Access Compliance Report

Public Rights-of-Way

(Curb Ramps)

Intersection ID: 3261	Main Street: BILLINGHAM_DR	Cross Street: MCKENDREE_WY	Location: SW
ADA ID: 9BAD22F4A41D	Ramp Type: Perp	Initial Pass/Fail: Fail	Overall Compliance: No
Severity Score: 8.75			
Codes/Mitigation Info/Possible Solution		Field Measurements/Component Compliance

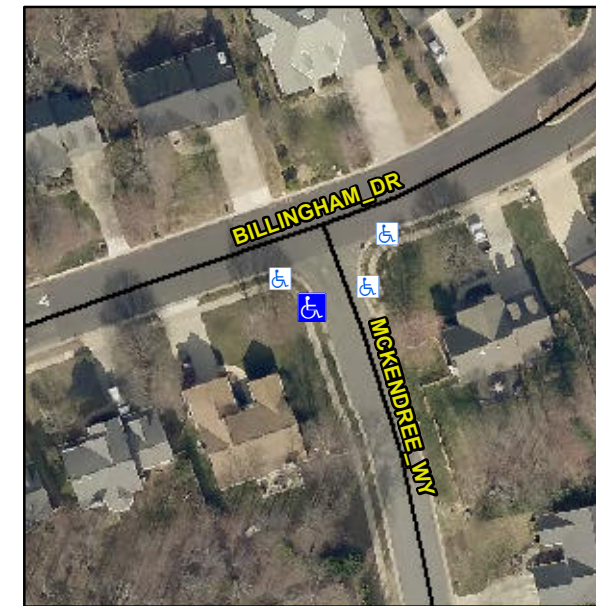
Not Found, R304.5.1

Compliance	Description	Data	Compliance	Description	Data
N/A	Ramp Length (in)	46.0	Yes	Ramp Slope (%)	5.4
No	Ramp Width (in)	46.0	Yes	Ramp XSlope (%)	1.9
N/A	Flare Type LT	N/A	N/A	Flare Type RT	N/A
N/A	Flare Slope LT (%)	N/A	N/A	Flare Slope RT (%)	N/A
N/A	Flare Traversable LT?	N/A	N/A	Flare Traversable RT?	N/A
N/A	Landing Length (in)	N/A	N/A	DWS Provided?	N/A
N/A	Landing Width (in)	N/A	N/A	DWS Contrast?	N/A
N/A	Landing Slope (%)	N/A	N/A	DWS Length (in)	N/A
N/A	Landing X Slope (%)	N/A	N/A	DWS Full Width?	N/A
N/A	Landing Curb? (Y/N)	N/A	N/A	DWS Offset (in)	N/A
N/A	Shared Landing?	N/A			
N/A	Gutter Ponding?	N/A	N/A	Gutter Slope (%)	N/A
N/A	Gutter Lip Ht (in)	N/A	N/A	Gutter X Slope (%)	N/A
N/A	Painted X Walk1?	No	N/A	Painted X Walk2?	N/A
	X Walk 1 Direction	To E		X Walk 2 Direction	N/A
N/A	X Walk 1 Width (in)	N/A	N/A	X Walk 2 Width (in)	N/A
	X Walk 1 Slope (%)	2.4		X Walk 2 Slope (%)	N/A
	X Walk 1 X Slope (%)	0.2		X Walk 2 X Slope (%)	N/A

Remove & Replace Entire Ramp.
